City of Lindsay

Hermosa Street/Westwood Avenue Roundabout Landscape Project – No. 1

Addendum/Clarification No. 2

2 SHRUB PLANTING
1" = 1'-0"

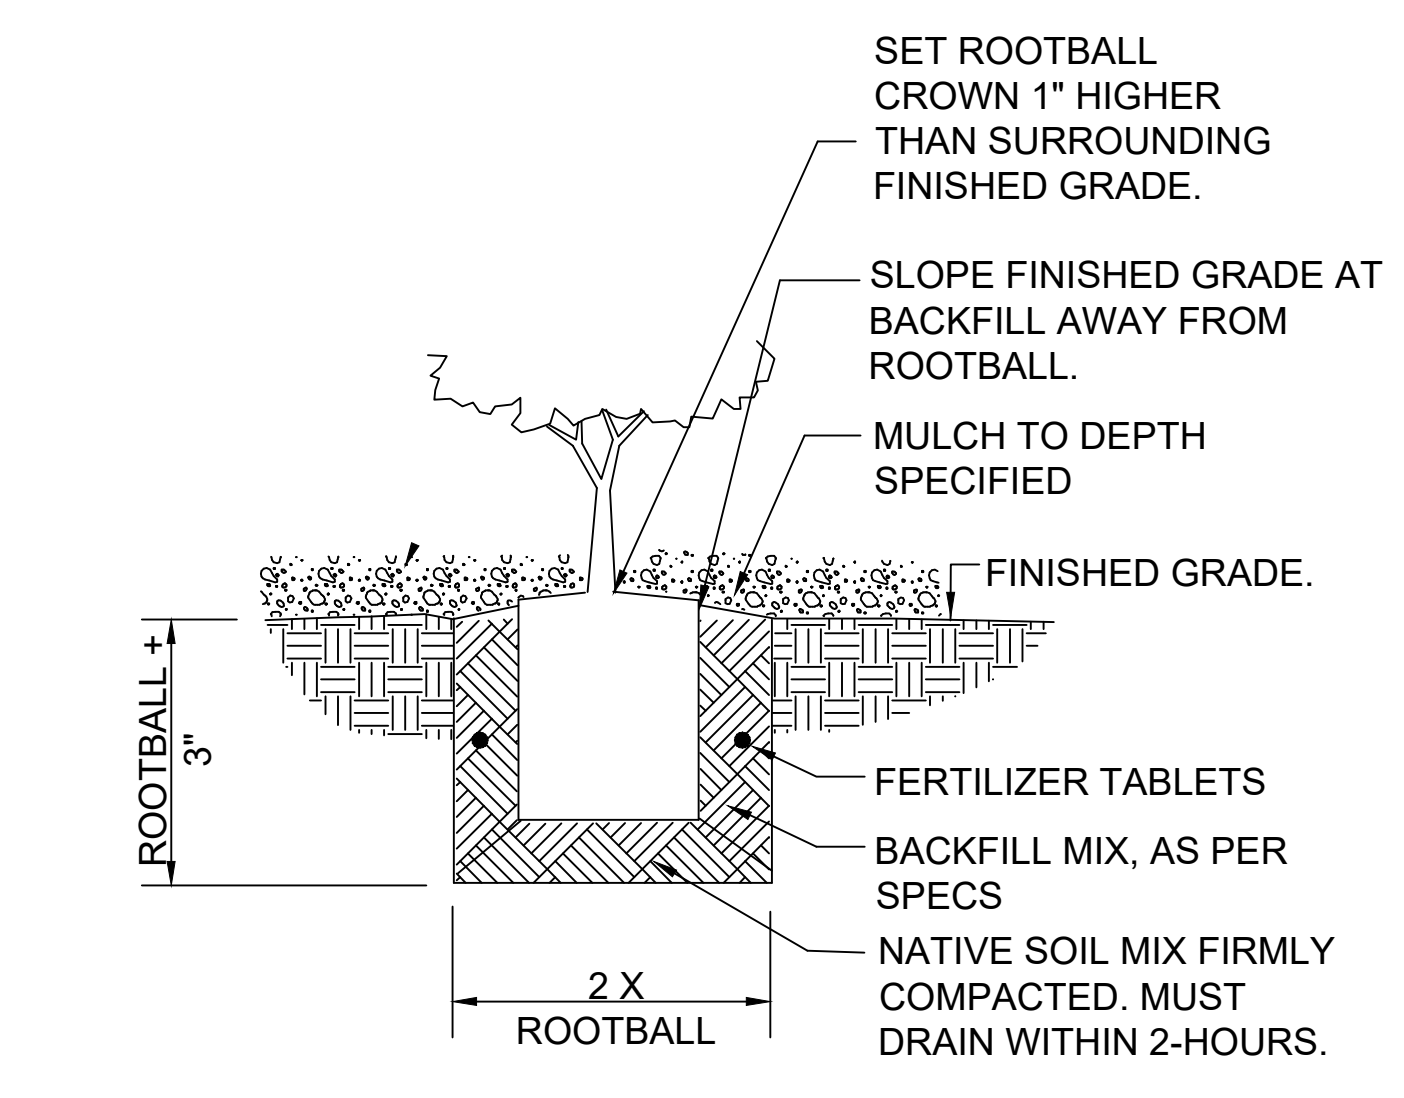
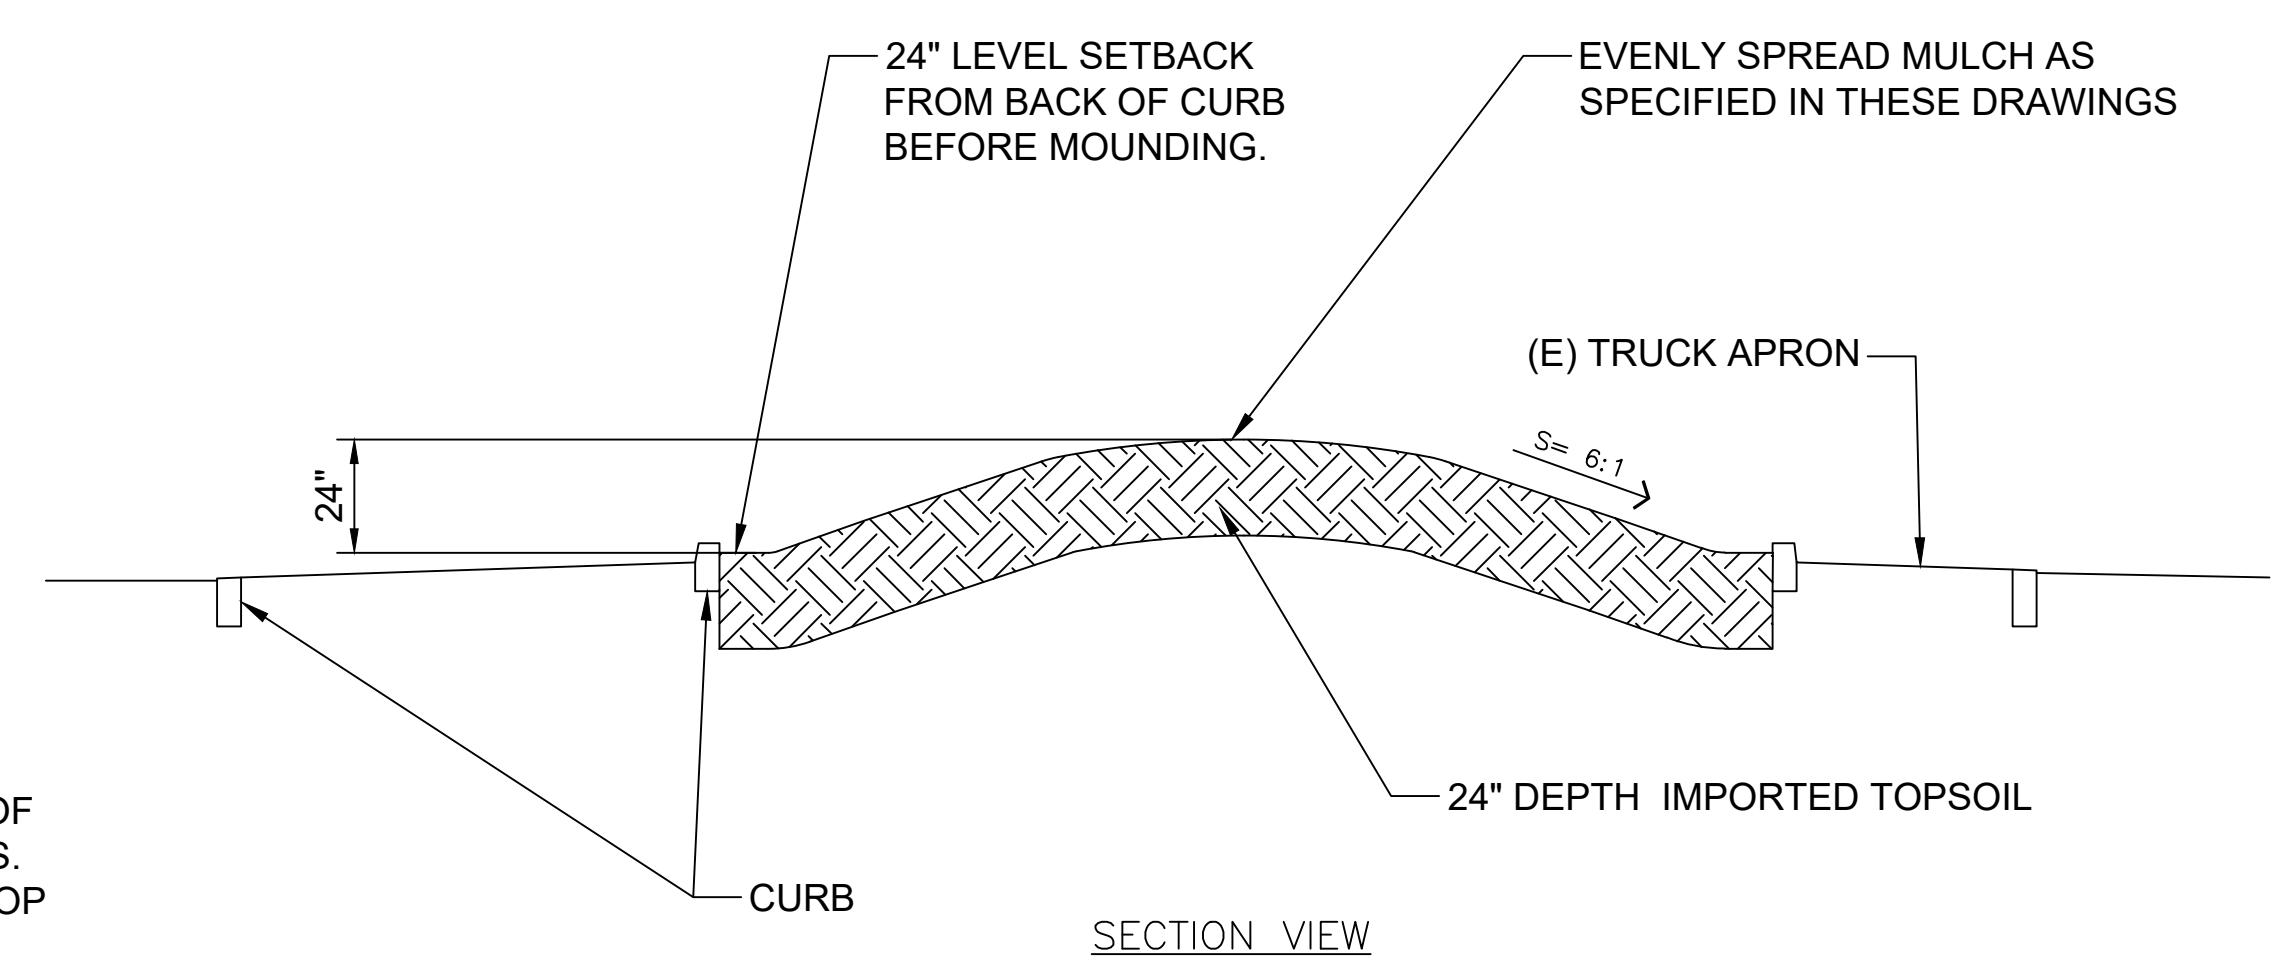
11. Q: Specifications refer to a tree staking detail but there is not such detail within the bid set, please provide so that we can include this as part of the proposal.

A: Please refer to the shrub planting detail.

IRRIGATION PLAN
HERMOSA STREET/WESTWOOD AVENUE
ROUNDAABOUT LANDSCAPE PROJECT - NO. 1
CITY OF LINDSAY

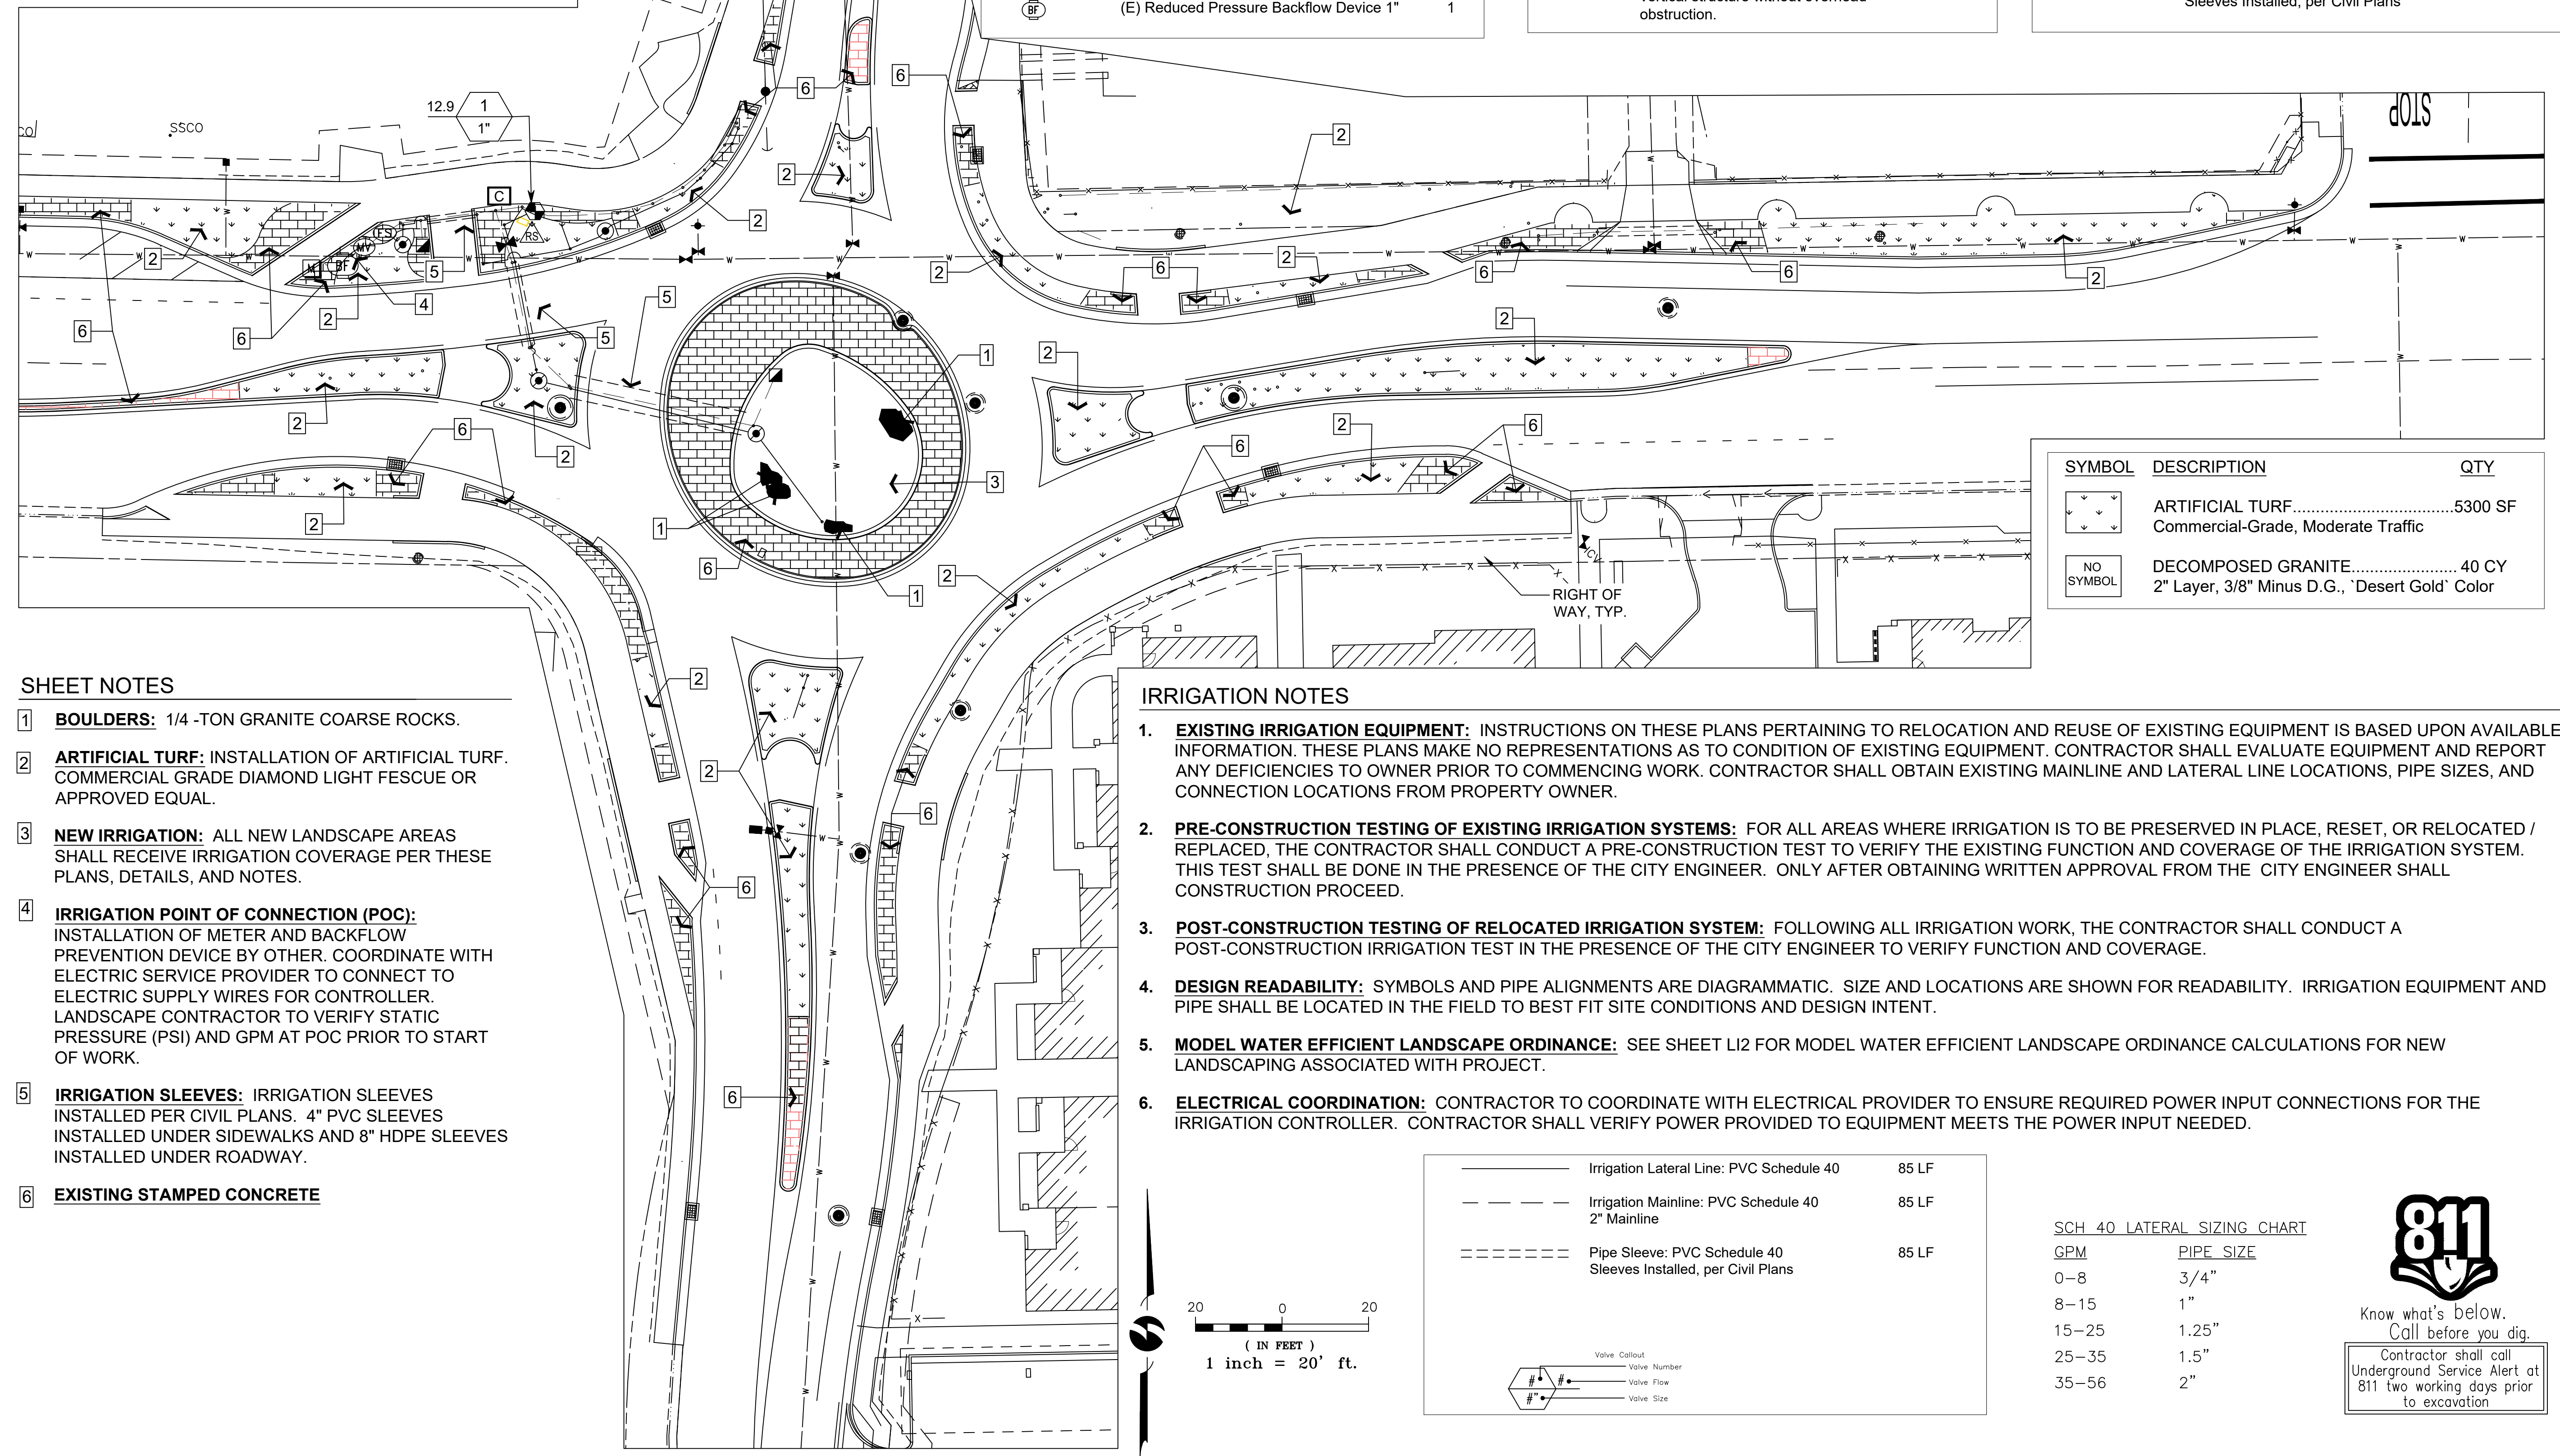
7. Q: Can you verify the power to the controller to be installed, plans only state on sheet LI-1 to coordinate with the electric service provider. Can you include more details?

A: Please see attached Civil Plans for reference (Addendum No. 2: Attachment #3). The existing power source is identified on the plans.

4 TOP OPENING PEDESTAL MOUNT CONTROLLER
NOT TO SCALE

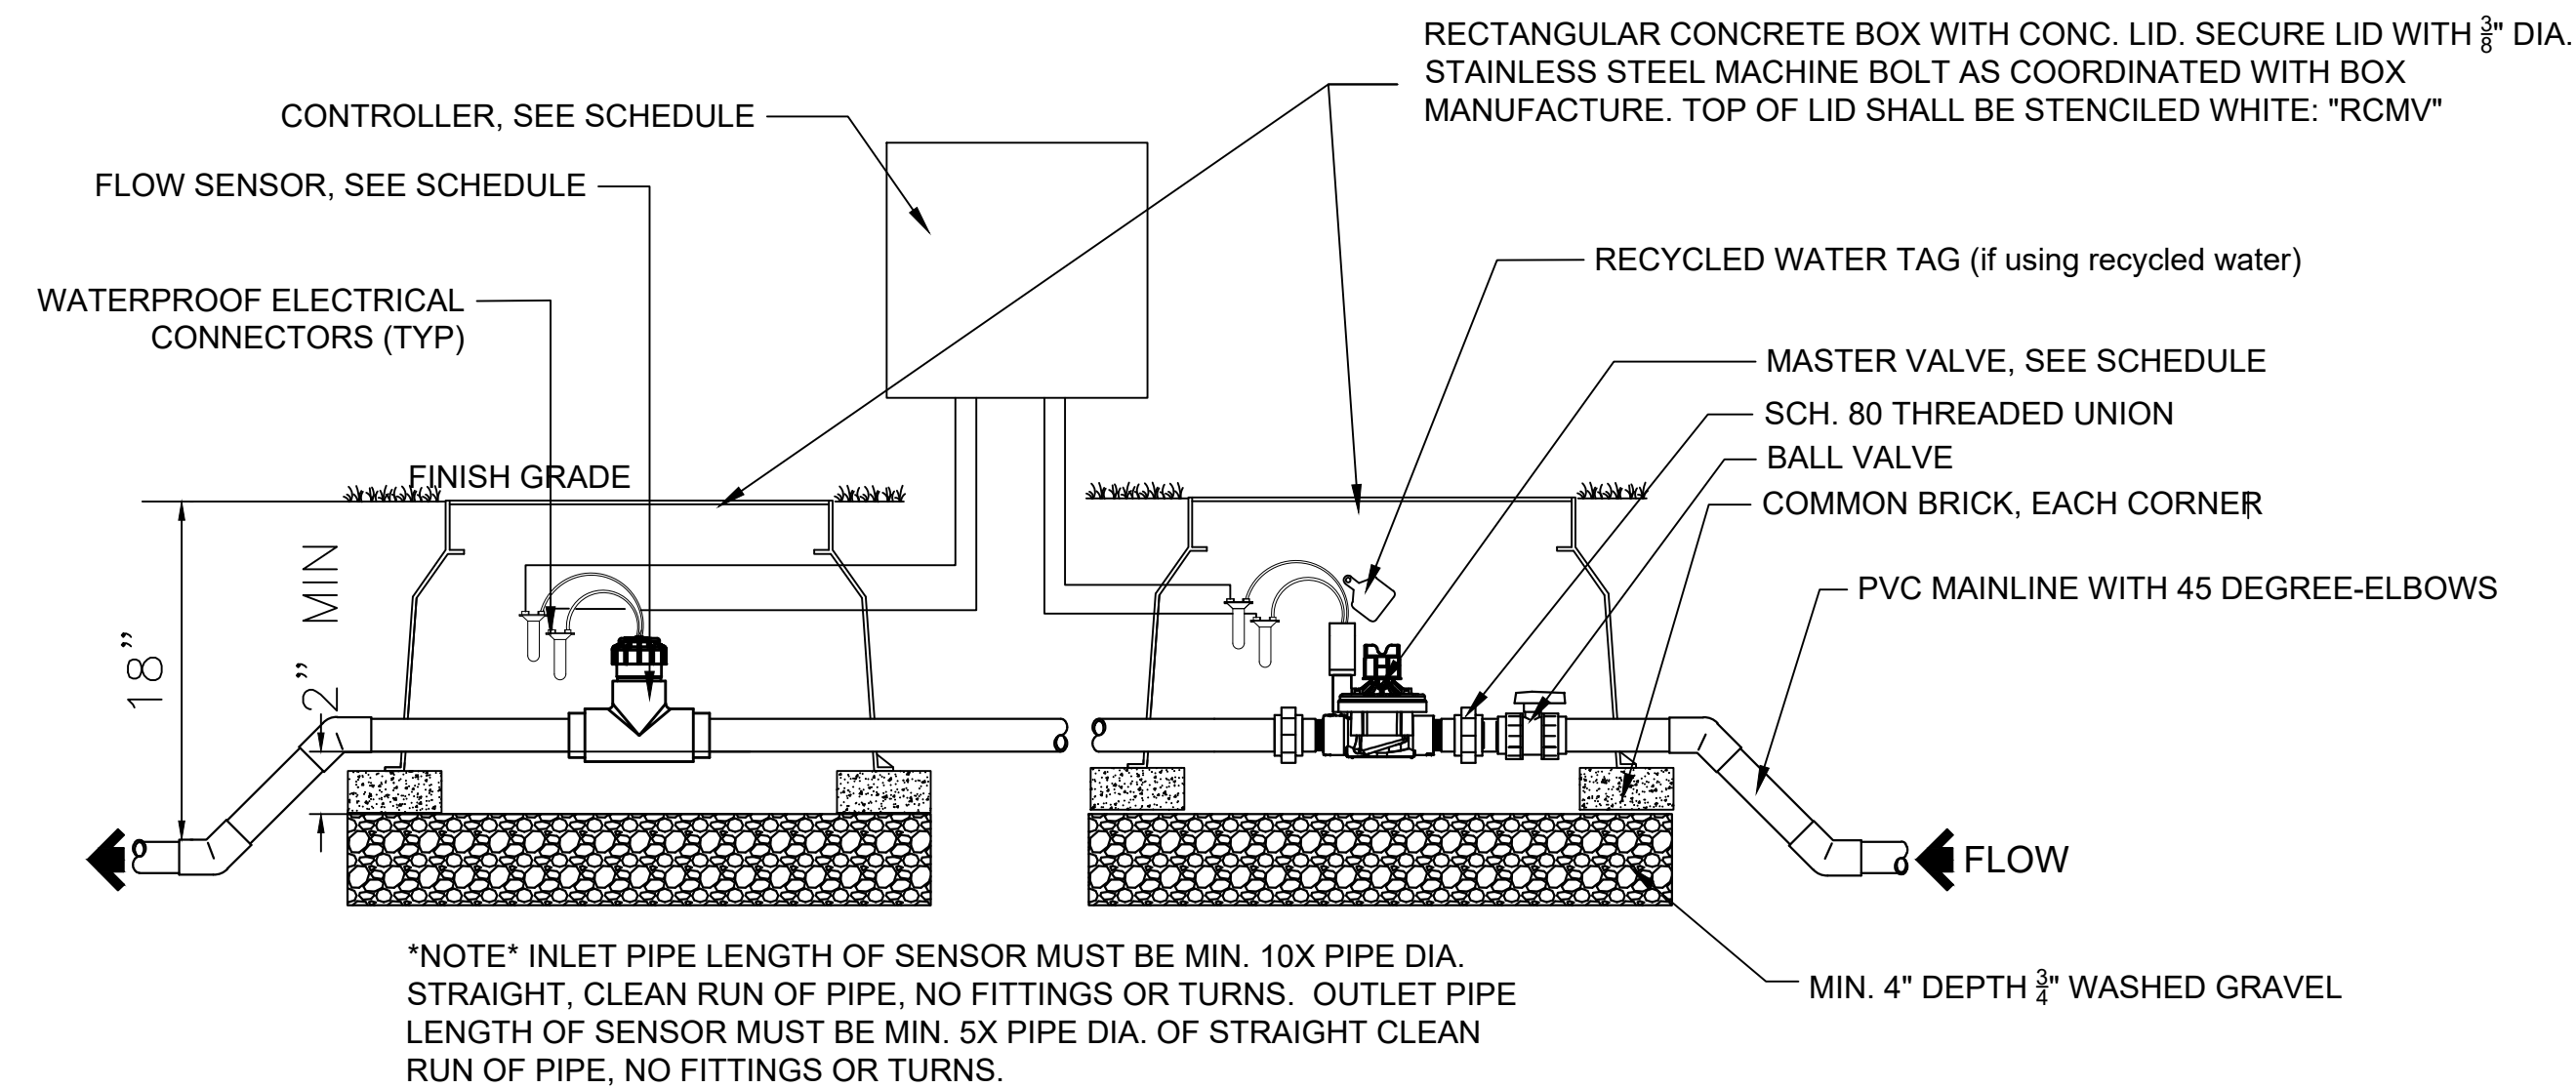
3. Q: The irrigation legend currently specifies a Hunter PED-SS pedestal, while the detail requires a Strong Box SB-16SS enclosure for the proposed irrigation controller; please advise which will be required for bidding purposes.

A: The Hunter IC-0600-PED-SS pedestal will be required for the bidding purposes of the project.
